HACKBARTH SUBDIVISION

Engineering Comments: **FINAL PLAT COMMENTS** (should be addressed prior to submitting the FINAL PLAT for review and/or signature by the City Engineer):

APPLICATION NUMBER 6 DATE October 7, 2021

DETAIL SITE PLAN

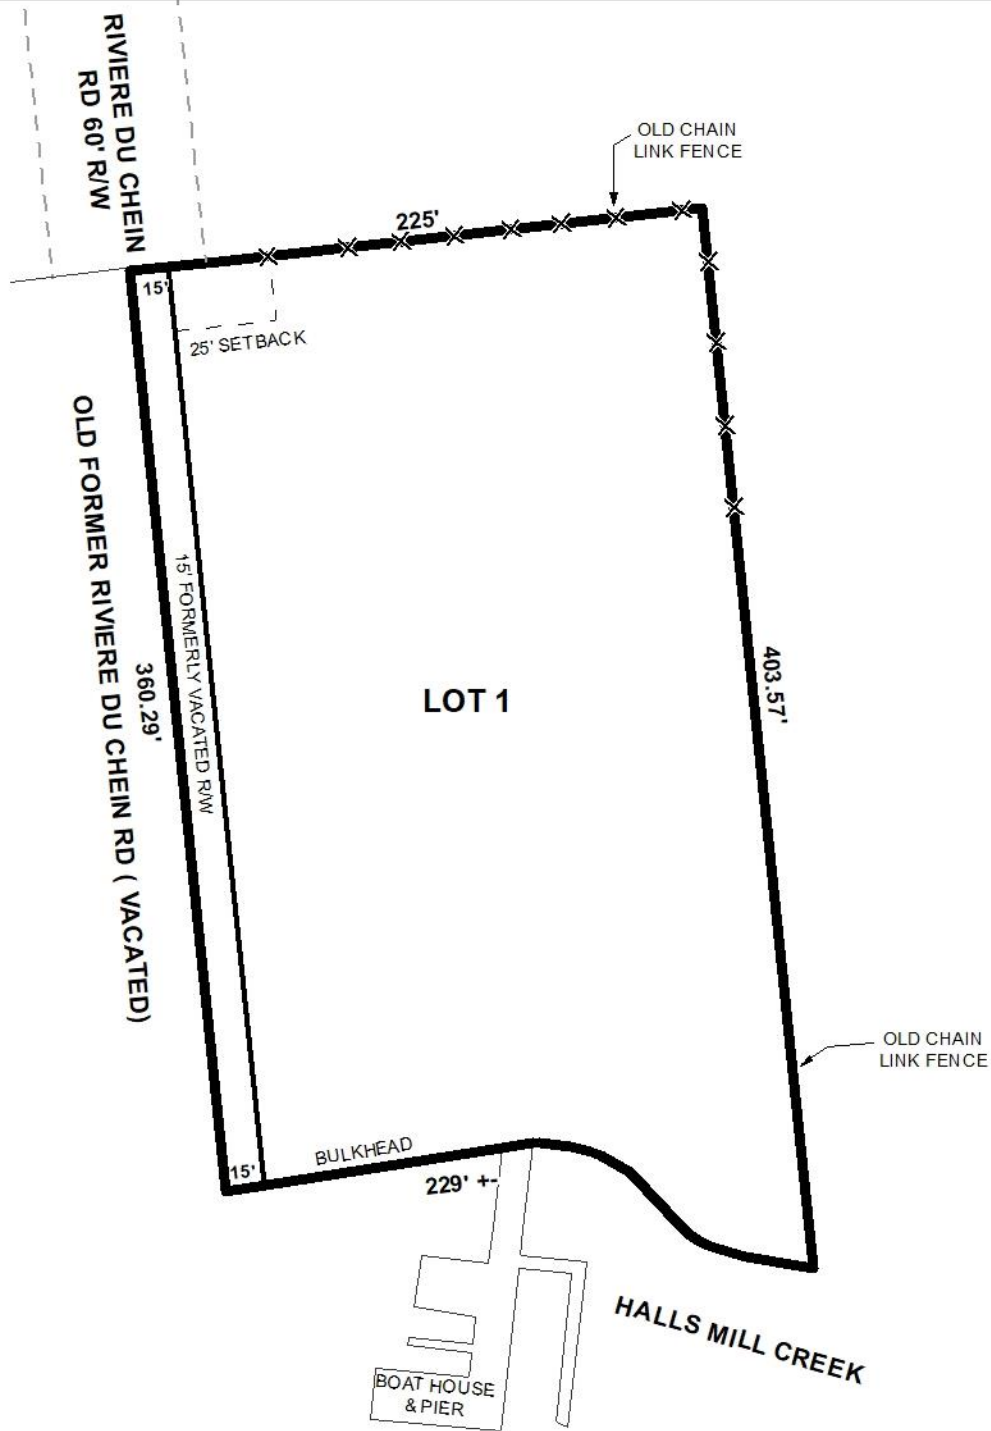
- A. Provide all of the required information on the SUBDIVISION PLAT (i.e. signature blocks, signatures, certification statements, written legal description, required notes, legend, scale, bearings and distances) that is required by the current Alabama State Board of Licensure for Professional Engineers and Land Surveyors.

- B. Provide a legible vicinity map that shows and labels the existing roads. Delete extraneous lines.
- C. Label all set or found property corners.
- D. Add "RBF" to the legend.

- E. Provide recording data for the vacated ROW.
- F. Revise the plat to label each lot with its size in acres and square feet, or the furnishing of a table on the Plat providing the same information.

- G. Show and label the MFFE (Minimum Finished Floor Elevation) - BFE = 11.
- H. Add a signature block for the Planning Commission, Traffic Engineer, and City Engineer.

- I. Provide the Surveyor's and Owner's (notarized) signatures.
- J. Add a note to the SUBDIVISION PLAT stating that as shown on the 1984 aerial photo (FLIGHT 24 - #89) LOT 1 will receive historical credit of existing (1984) impervious area towards stormwater detention requirement per Mobile City Code, Chapter 17, Storm Water Management and Flood Control) as follows: LOT 1 – NONE.

- K. Add a note that sidewalk is required to be constructed, and/or repaired, along the frontage of each lot, or parcel, at time of new development or construction, unless a sidewalk waiver is approved.

- L. Add a note that all existing and proposed detention facilities, common areas, and wetlands shall be the responsibility of the Property Owner(s), and not the responsibility of the City of Mobile.

The site has frontage on Riviere Du Chien Road a minor street without curb and gutter. As such, the preliminary plat illustrates a compliant 60-foot right-of-way width which should be retained on the Final Plat, if approved.

As on the preliminary plat, the 25-foot minimum building setback line should be retained on the Final Plat. The proposed lot meets the minimum size requirements of the Subdivision Regulations, however, this information is not illustrated on the preliminary plat. The Final Plat should be revised to include the lot size labeled in both square feet and acres, or a table should be furnished on the Final Plat providing the same information.

No easements are indicated on the preliminary plat. If any easements are recorded on the site they should be indicated and labeled on the Final Plat, and a note should be placed on the Final Plat stating that no structure may be placed or constructed within any easement without permission of the easement holder.

- 1) retention of the right-of-way width of Riviere Du Chien Road on the Final Plat;
- 2) retention of the 25' minimum building setback line on the Final Plat;

- 3) revision of the Final Plat to label the lot size in both square feet and acres, or the furnishing of a table on the Final Plat providing the same information;

- 4) placement of a note on the Final Plat stating that no structure may be constructed or placed within any easement without the permission of the easement holder, if applicable;
